**LEBANON PLANNING BOARD
APRIL 28, 2025 - 6:30 PM
COUNCIL CHAMBERS, CITY HALL OR
REMOTE VIA VIRTUAL PLATFORM
LEBANONNH.GOV/LIVE**

Re: Site Plan Amendment Application
Lot 78-40-2, 51 Evans Drive
PB2024-48-SPACUP

RE: SITE PLAN REVIEW APPLICATION NO. PB2025-16-SPR RESUBMISSION, UPPER VALLEY MUSIC CENTER, BUILDING ADDITION AND SITE IMPROVEMENTS PROJECT, 8 SOUTH PARK STREET, LEBANON, NEW HAMPSHIRE (Project No. 13444)

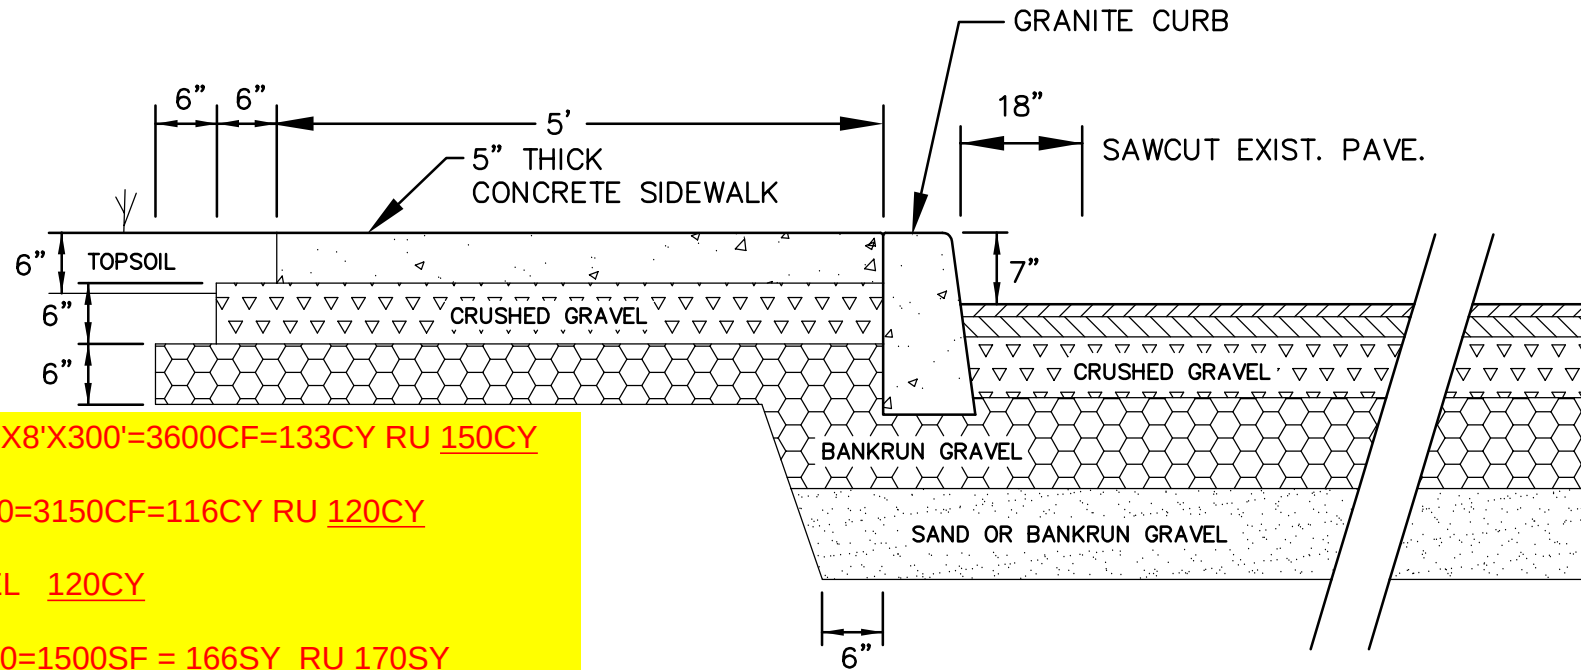
1. As discussed last night, at your earliest convenience, please provide Brian with an estimate of the cost to construct a sidewalk along the property's Evans Drive frontage.

1. We agree to an extension of the time limit for the Planning Board review and decision.
2. Sidewalk. Attached is an estimate for construction of 300LF of new sidewalk. We oppose the imposition of this expense for two reasons: 1) it is part of the existing site and is not part of the proposed improvements, and 2) there is no need for this improvement on this side of the road. There is a brand new sidewalk on the opposite side of the road. (see attached photos).

L-1

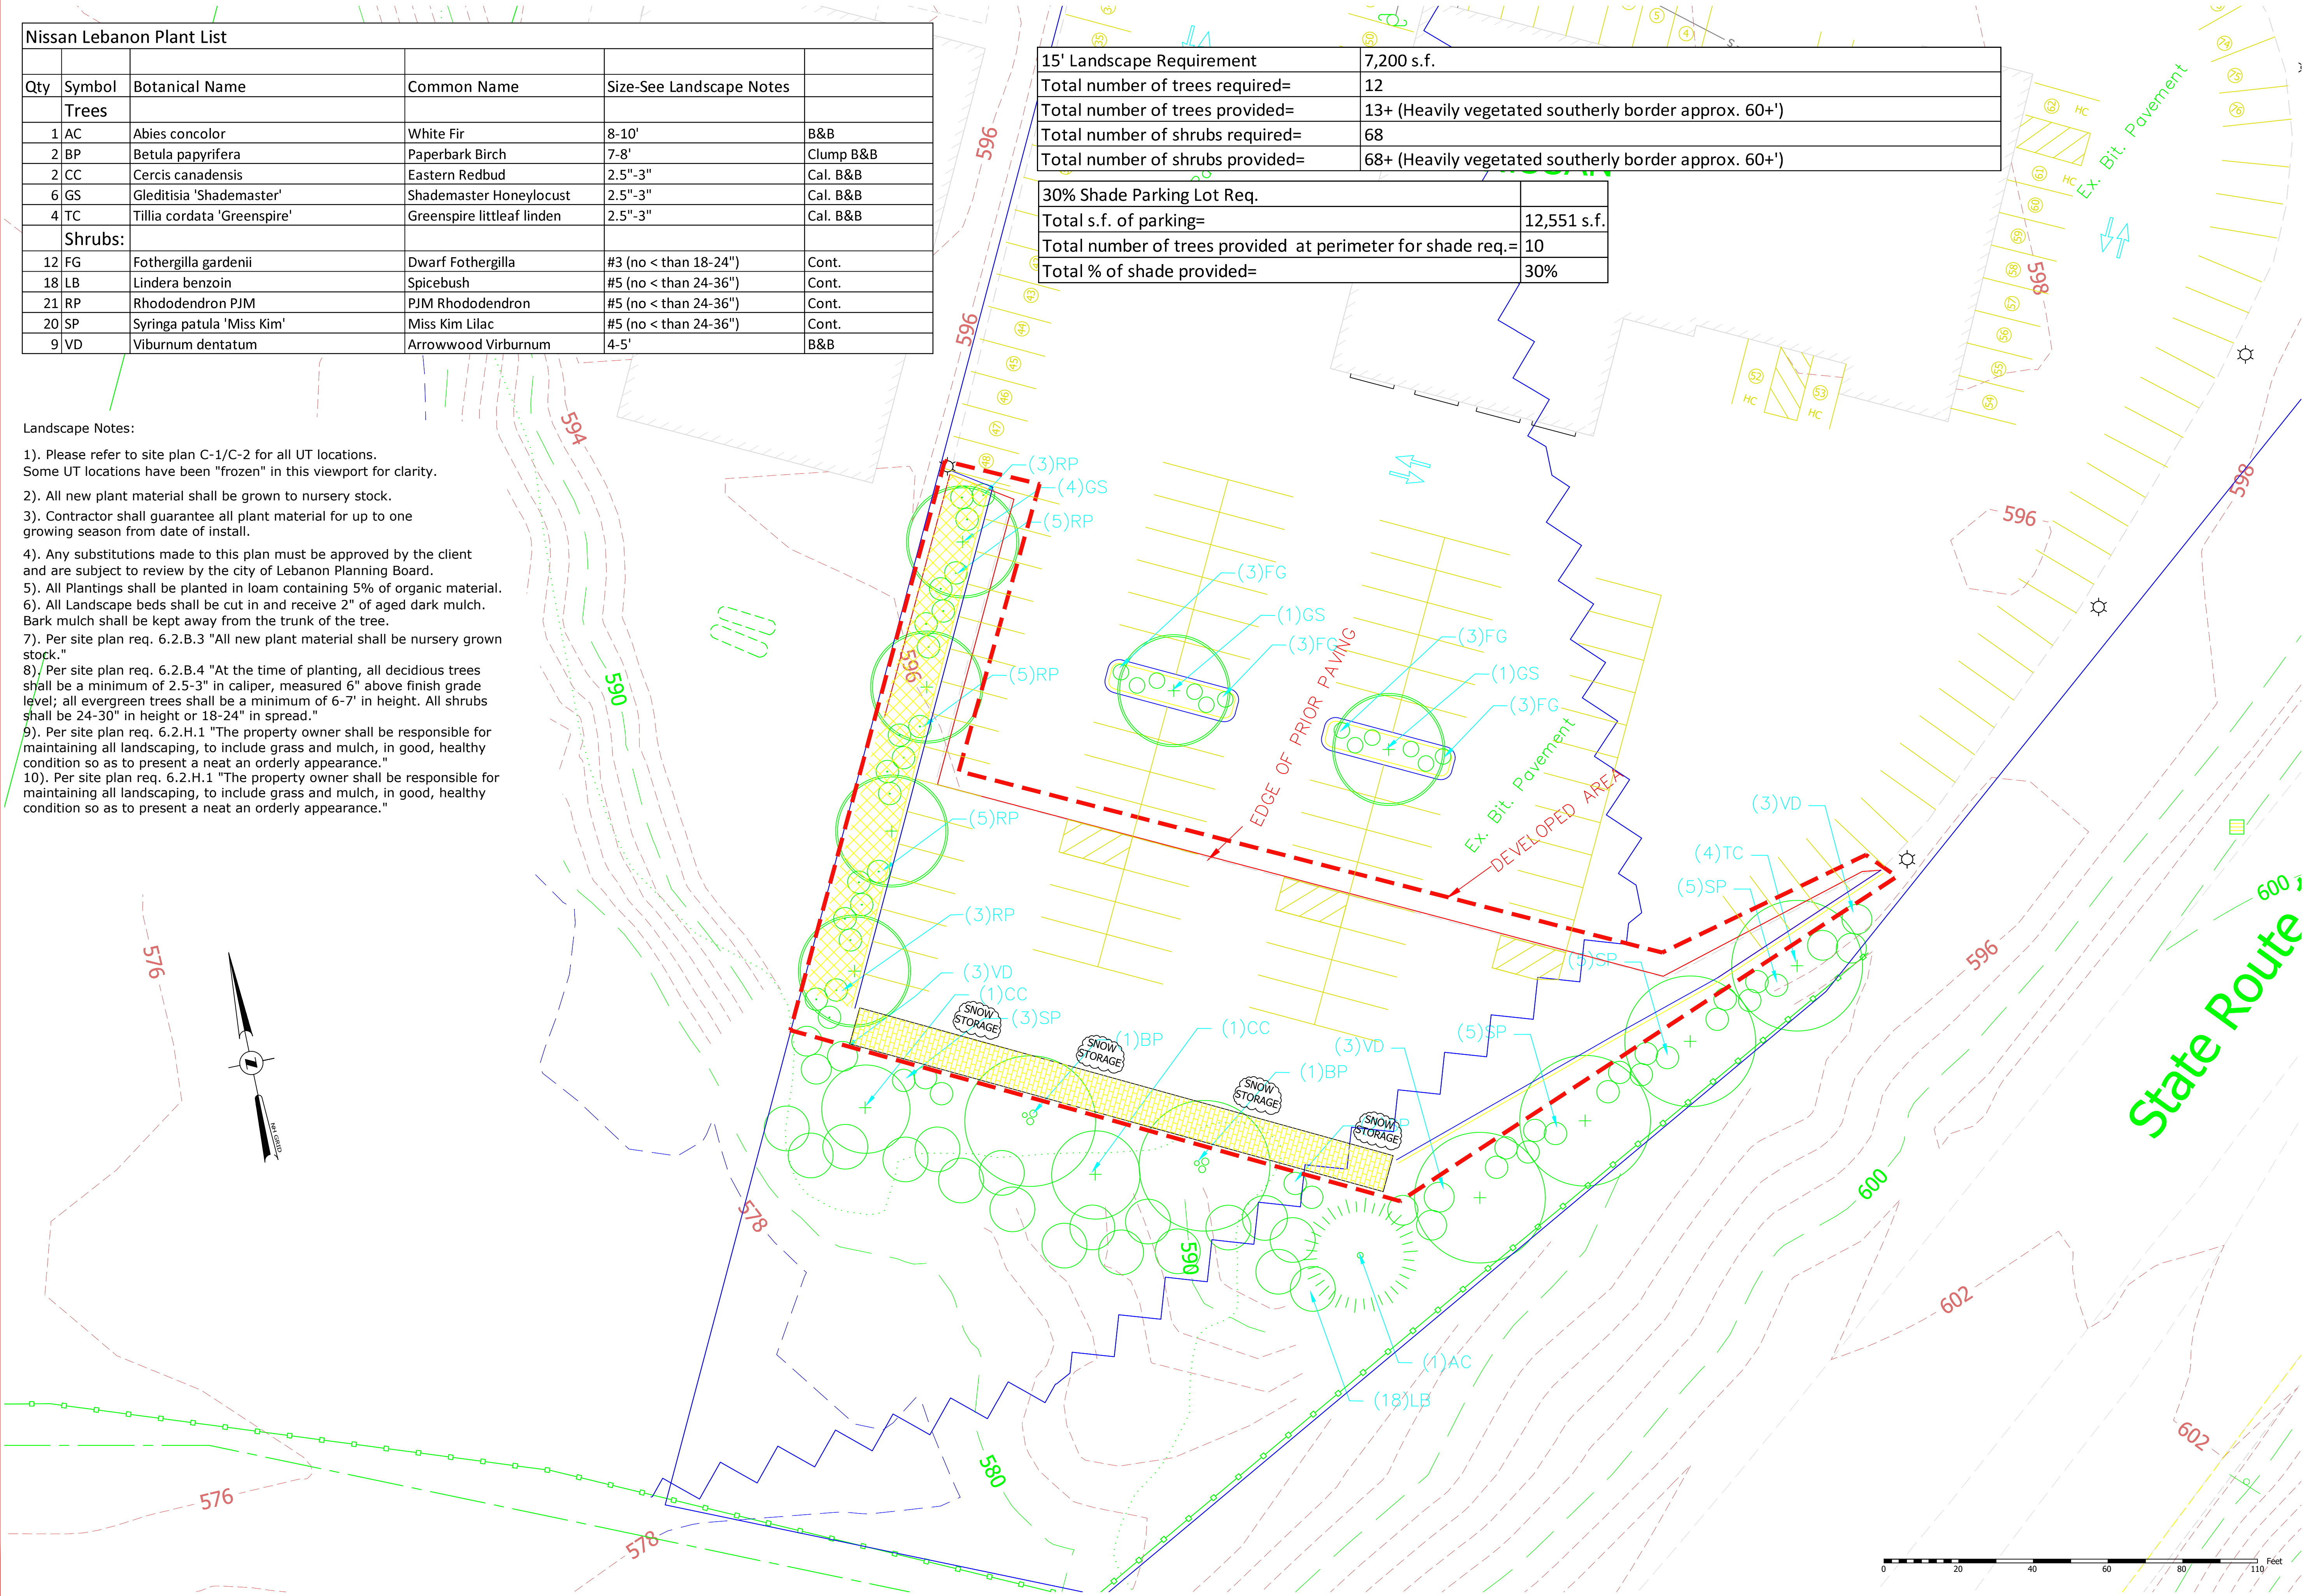
1. In addition to making any changes pursuant to #2 above, on the landscaping plan sheet:

- * please identify how and with what the proposed landscaping islands will be planted.
- * Rather than meeting the 30% shading requirement just for the proposed expansion area, please consider adding additional landscaping around the perimeter so that the 30% shading requirement is met for the entire back half of the property, i.e. from the rear of the building to the edge of pavement at the southern end of the proposed paving.

4. The landscape plan indicates proposed plantings. My client has considered expanding the perimeter landscaping but chooses not to. The shading requirement is met for the expanded area of parking.

30% Shade Parking Lot Req.	
Total s.f. of parking=	12,551 s.f.
Total number of trees provided at perimeter for shade req.=	10
Total % of shade provided=	30%
